Re: **Windhaven Estates Re-Plat Review**

Re: **Windhaven Estates Preliminary Civil Construction Plans - Review #1**  
Dear Ms. Hammonds,

Halff Associates, Inc. was requested by the City of Sanger to review the Preliminary Civil Construction Plans for the Windhaven Estates. This submittal was prepared by Homeyer Engineering, Inc and was received on November 4<sup>th</sup>, 2024.

PRELIMINARY CIVIL CONSTRUCTION PLANS  
for  
Windhaven Estates  
19.50 Acres  
City of Sanger  
Denton County, Texas  
October 2024

PROPOSED  
 STORM PLAN

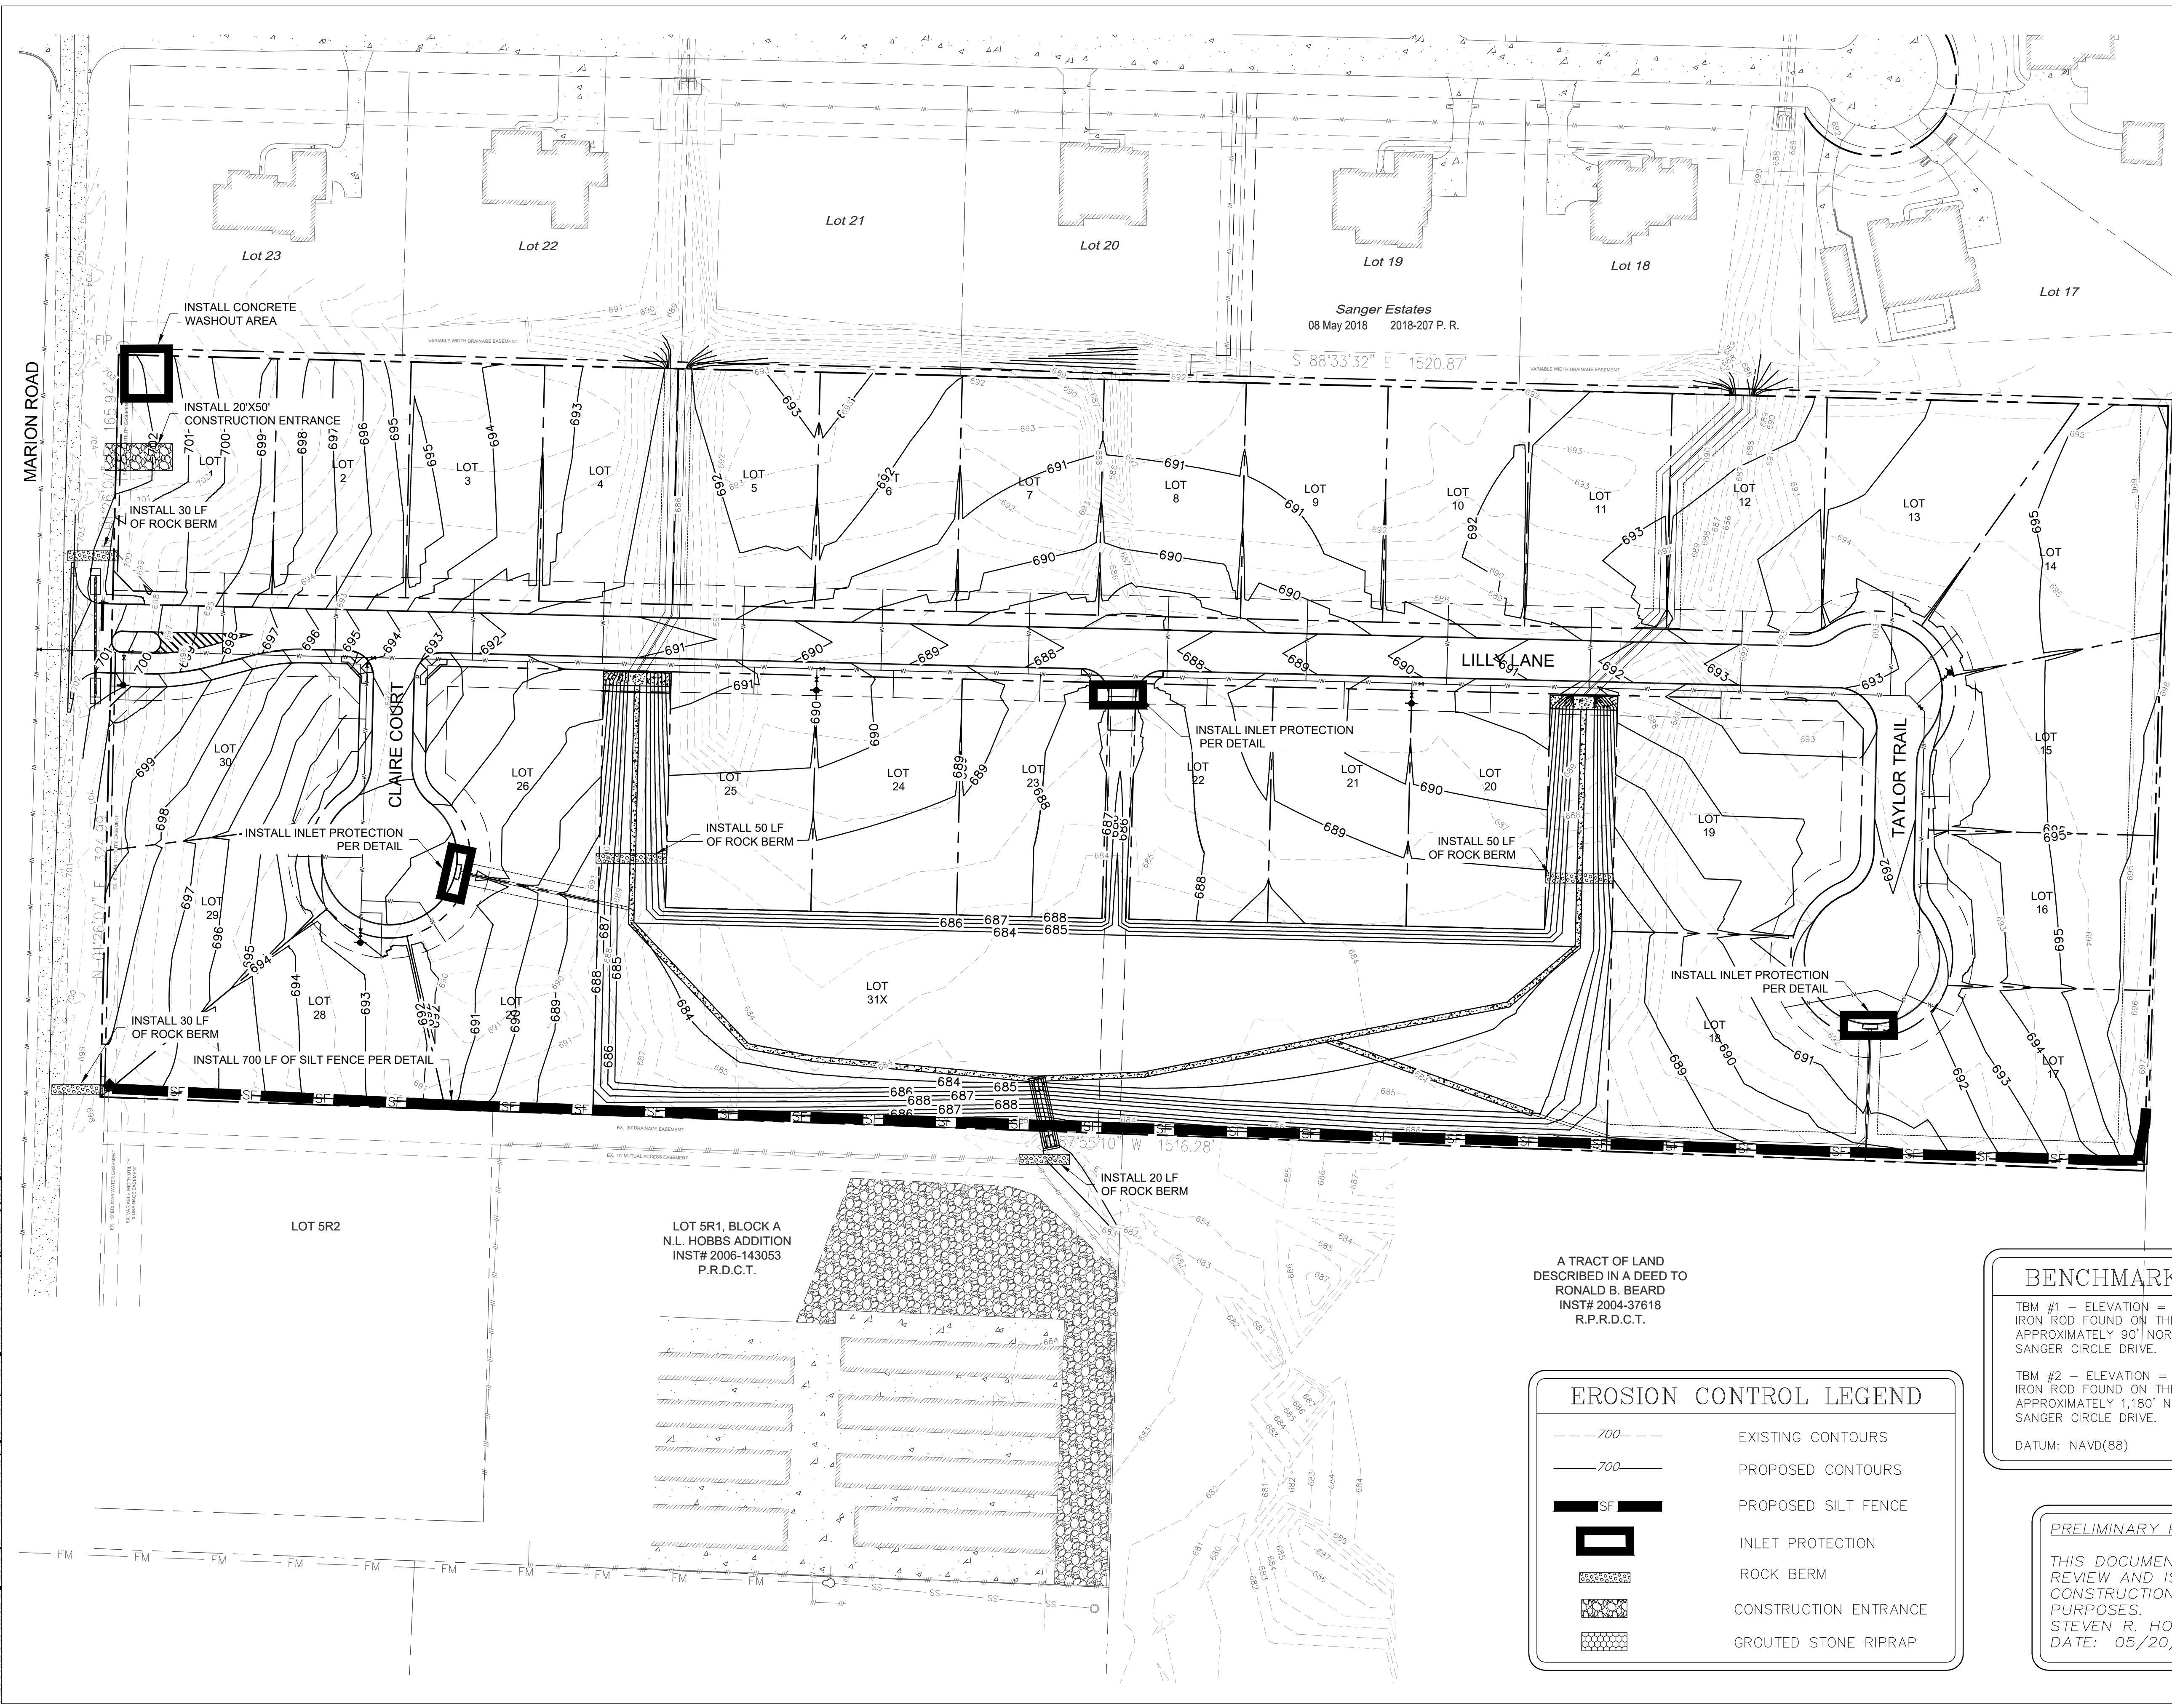
Provide Inlet Calculations, hydraulic calculations and storm drain plan and profiles for each storm system

OVERALL  
 SANITARY  
 SEWER PLAN

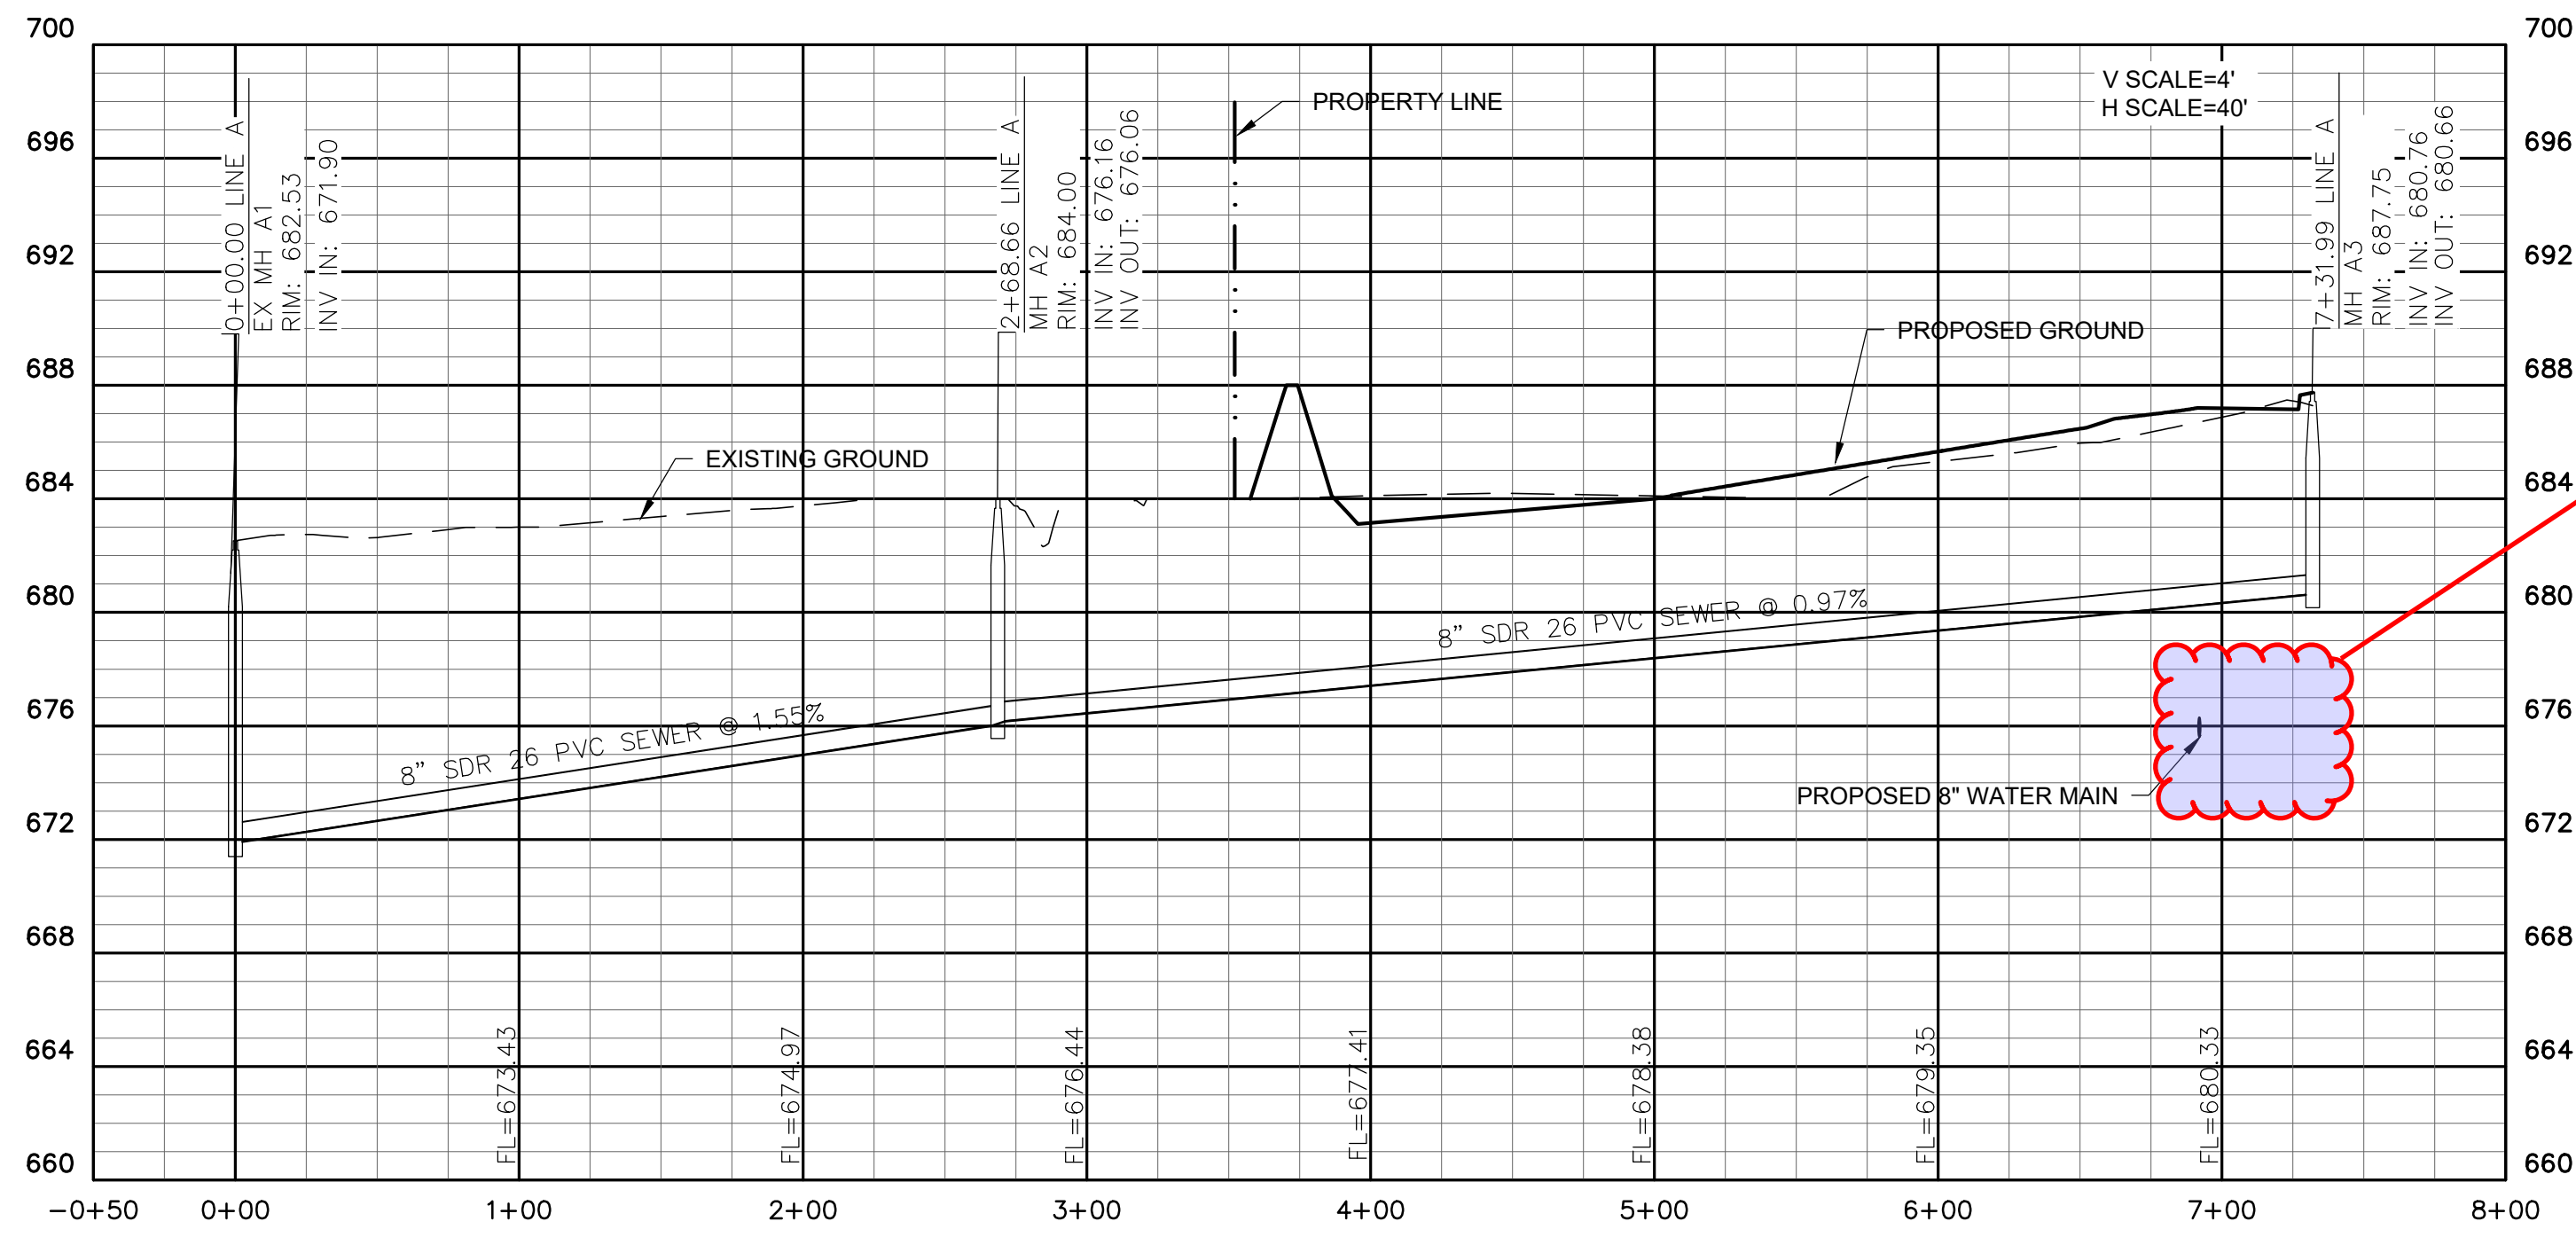
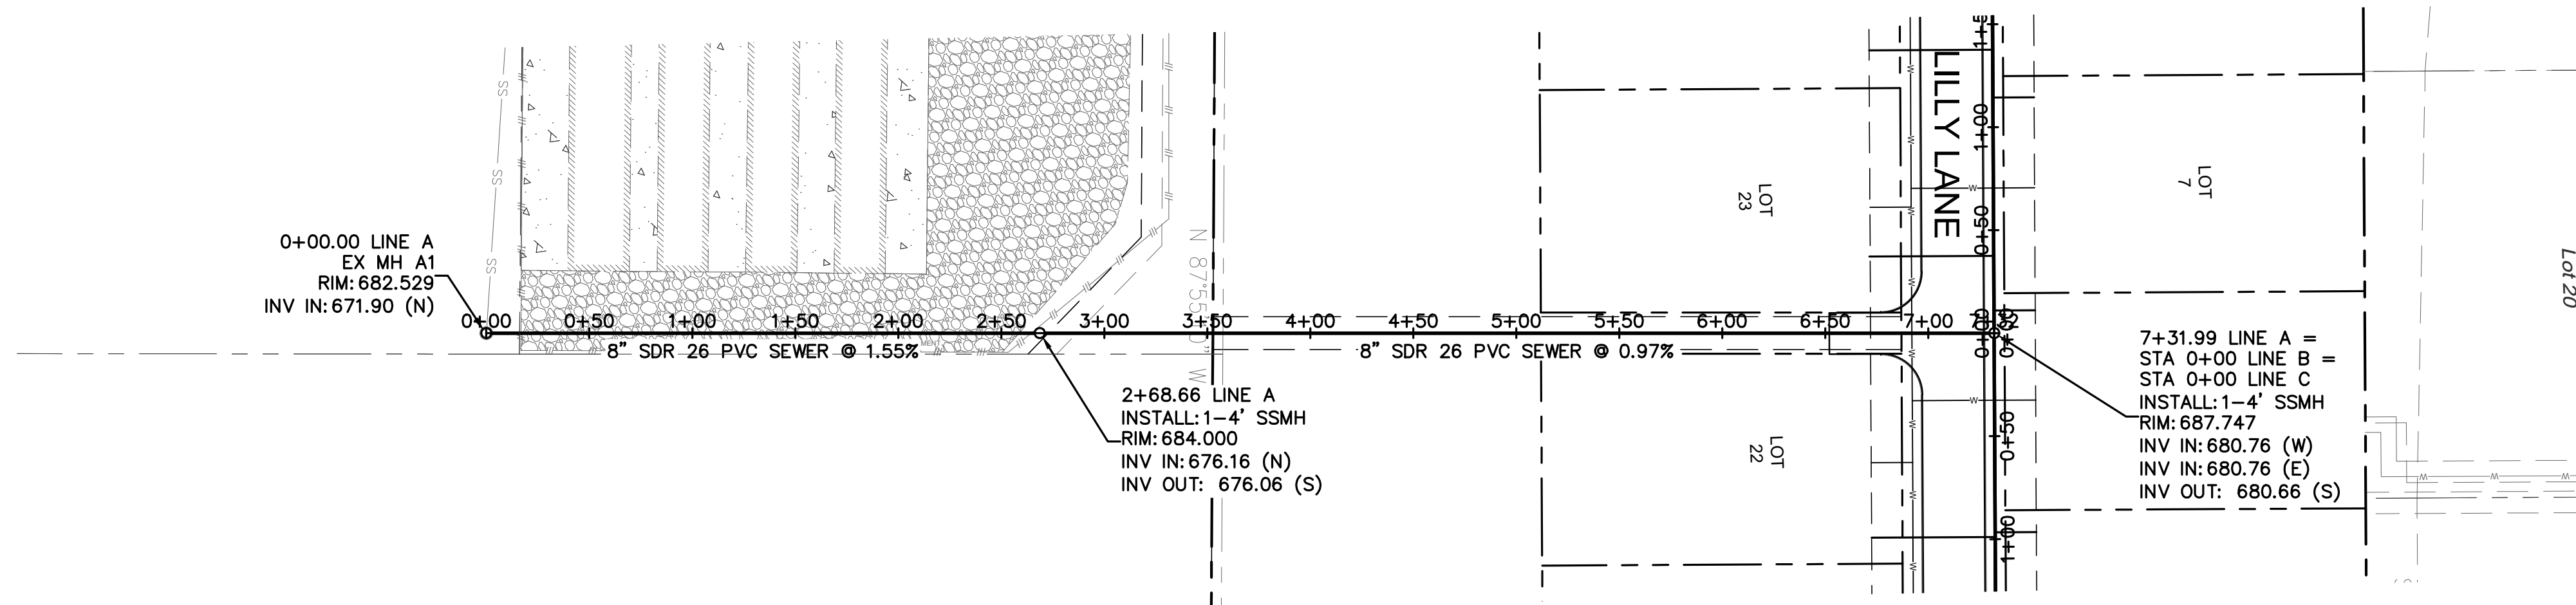
Ensure that 18' min segment of water line is perpendicular to and centered on sewer pipe. Verify that segment is either constructed of ductile iron/steel or encased in cement stabilized sand embedment
